# AM335x General-Purpose EVM (Revision 1.1)

## Errata

Literature Number: SPRUHD7  
January 2012

**Figure 1. PORz Circuit**

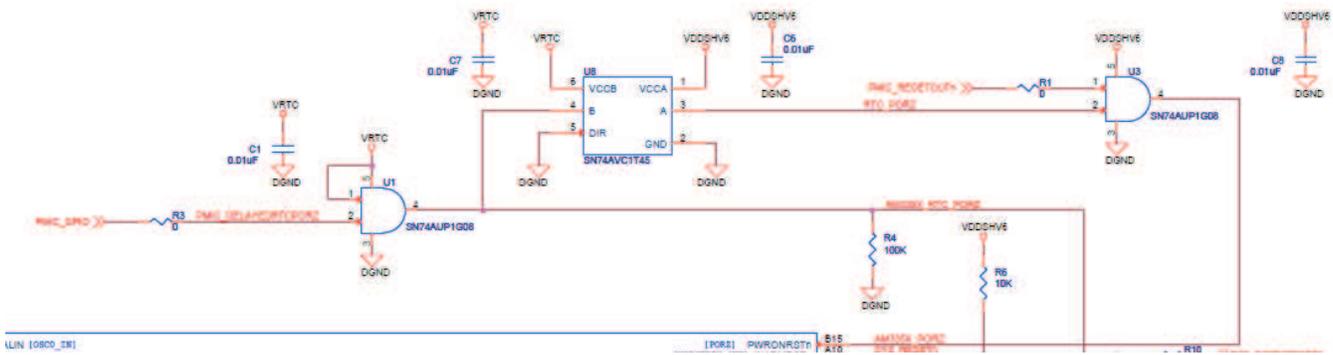
**Details:**                      The logic driving the PWRONRSTn input on the AM335x device is at 1.8-V level instead of the VDDSHV6 level (3.3 V). Since this input generates a reset when active, this lower level may drive the board into reset when not intended.

- Remove U1.
- Add an SN74AUP1G08, an SN74AVC1T45, and an SN74AUP1G08 so that PWRONRSTn on the AM335x device is driven to the correct voltage level (see [Figure 1](#)).
